ADDENDUM NO. 2

DATE: July 6, 2023
FROM: City of Grand Junction Purchasing Division
TO: All Offerors
RE: Remodel of Fire Station #5 IFB-5266-23-DD

FIRE STATION No. 5
FLOOR PLAN

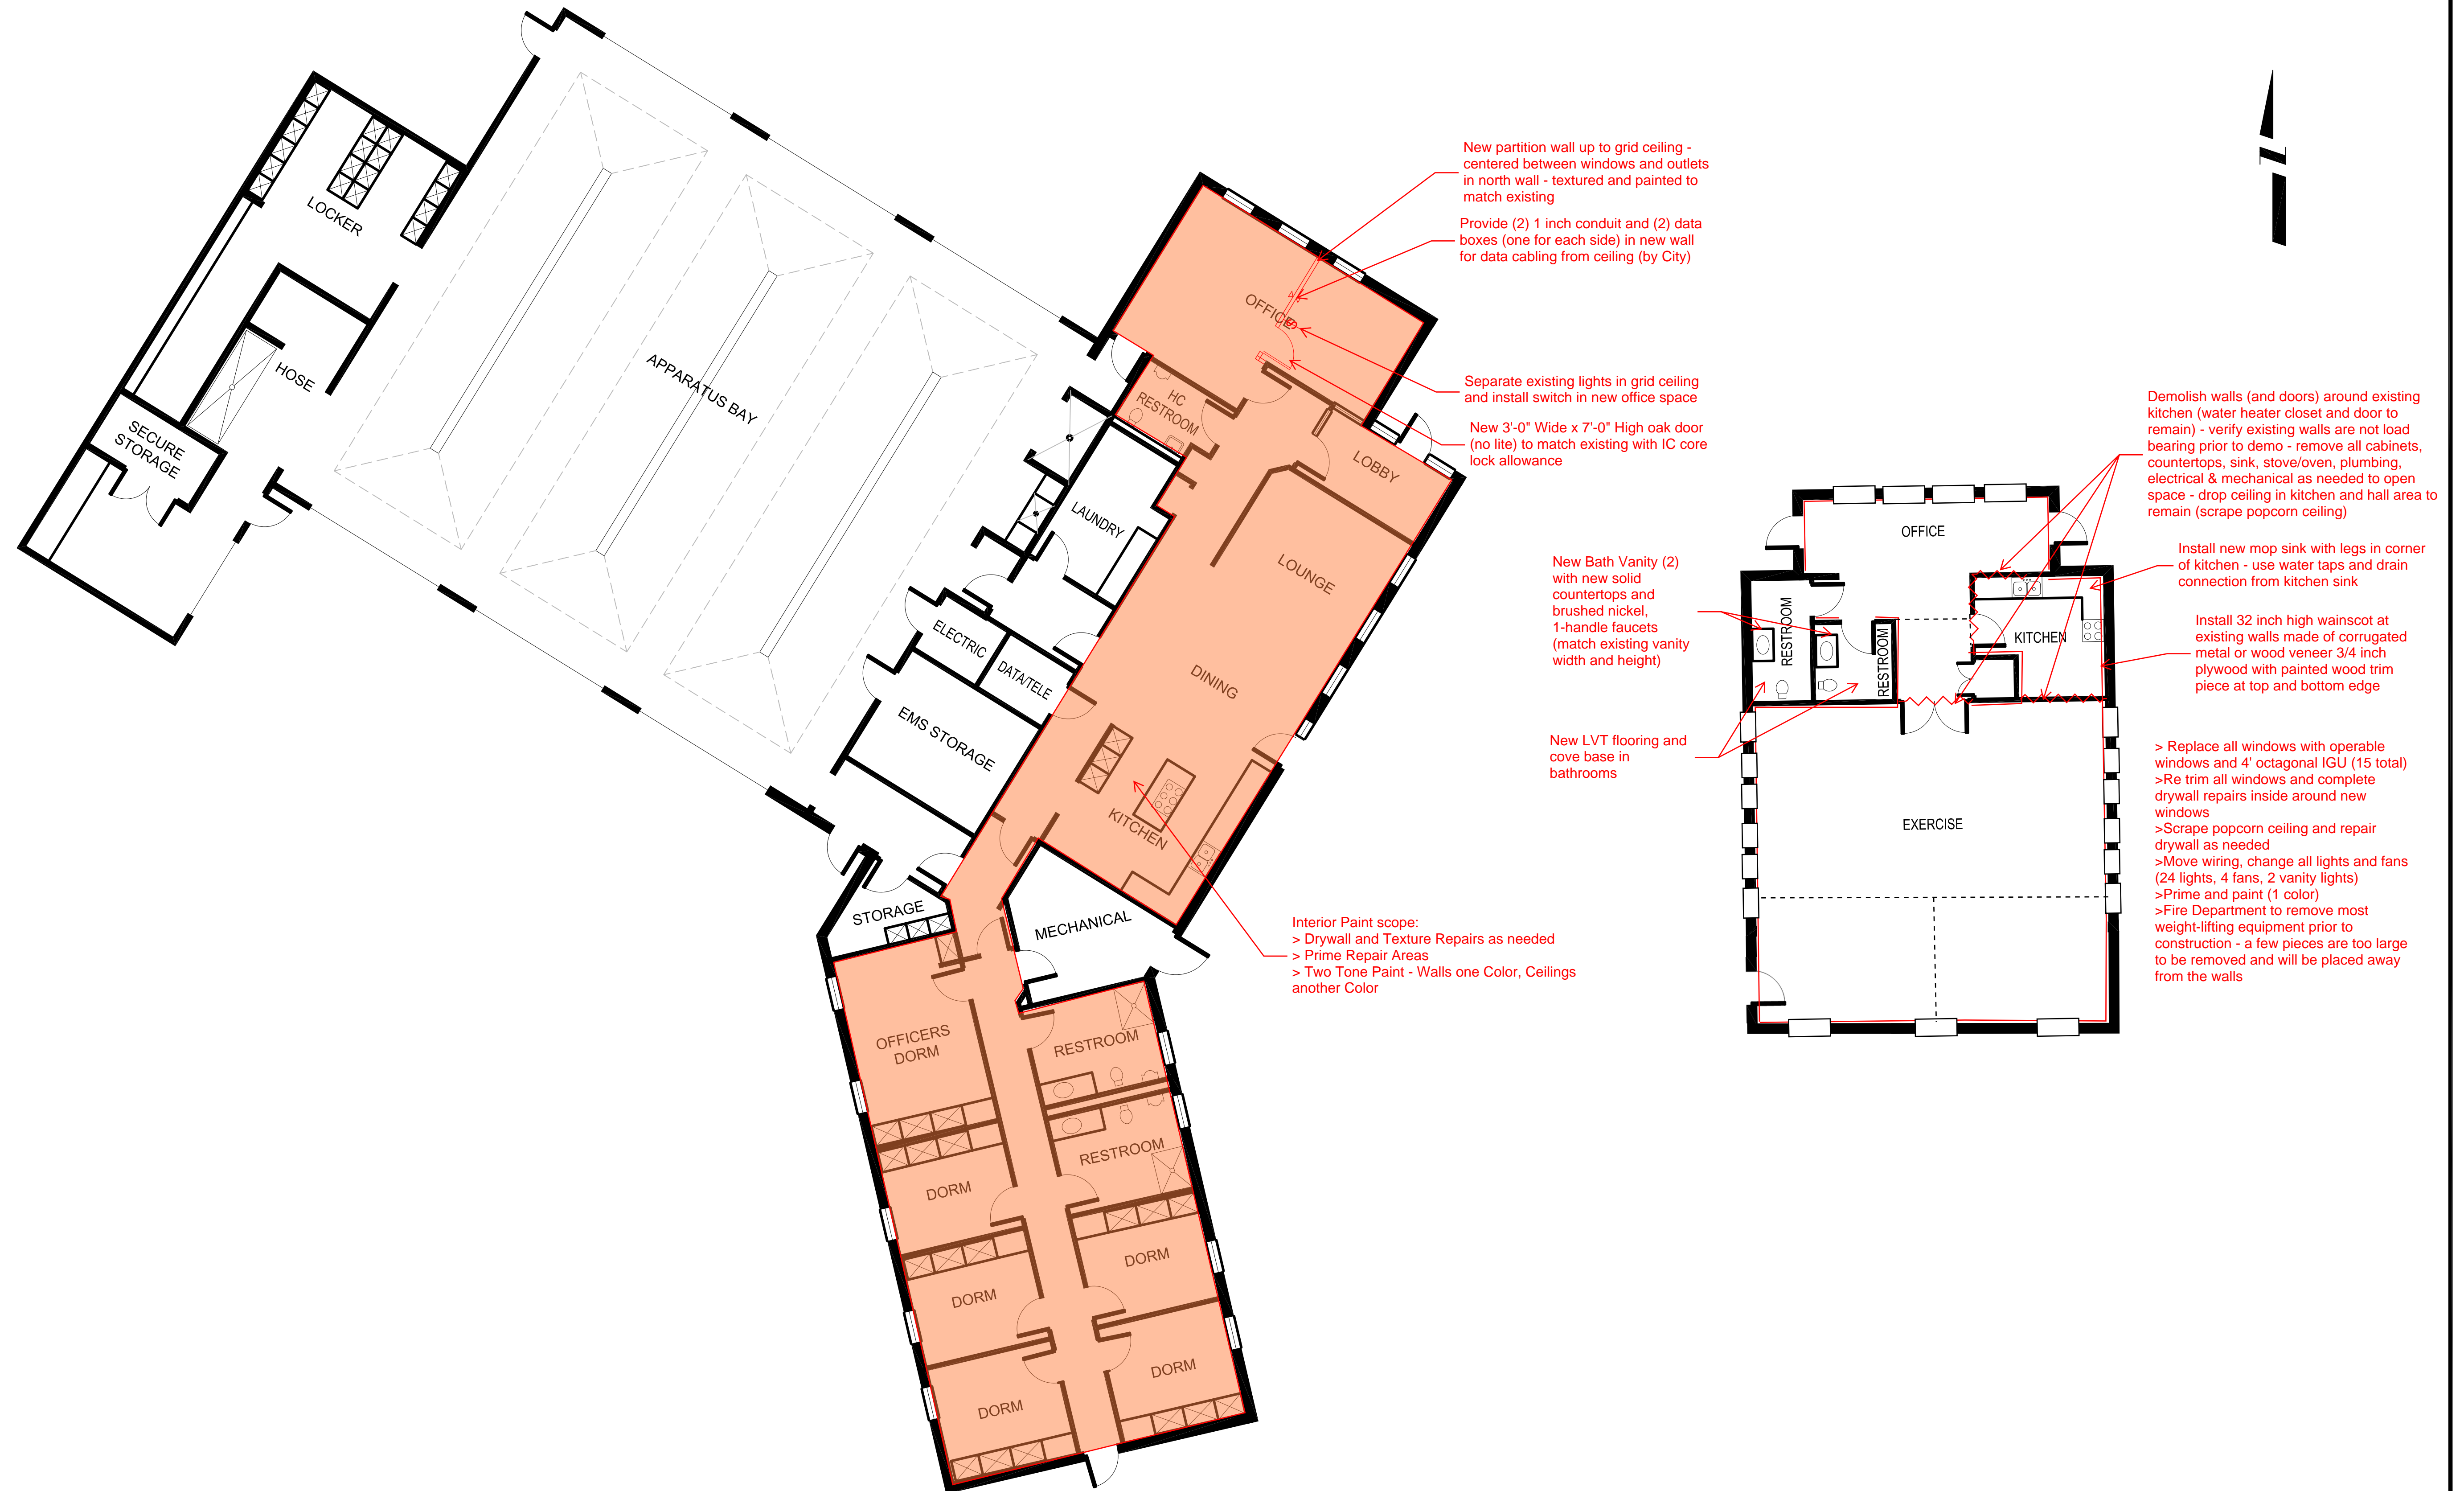
- 2. Q:** It calls out for a new bath vanity. Is there a particular finish you would like to see and what type of top? There are many choices, plastic laminate, solid surface?
A: A one piece vanity as shown or equal to the vanity in the following link with solid surface countertops and brushed nickel finishes: <https://www.lowes.com/pd/Project-Source-Gray-30-in-Gray-Undermount-Single-Sink-Bathroom-Vanity-with-White-Cultured-Marble-Top/5002135527>
This has been included in the attached updated plans.

- 4. Q:** It is calling out for a utility sink that is shown in the bathroom. Is this the location you wish to have it in? Utility sinks that come with legs would be the easiest solution due to the fact we can drop the drain in through the wall in most cases vs a mop sink which sites on the floor that would require concrete removal to install a drain?
A: Please provide a utility sink with legs to eliminate the need for concrete removal. Note: Revised drawings show utility sink location moved to the kitchen area.

10. **Q:** To what extent where we frame new wall in the office portion of main firehouse are we painting? Just new wall or everything new or entire room?

A: The plan has been updated to show the areas needing paint as part of the scope item 3.4.3. (Attached)
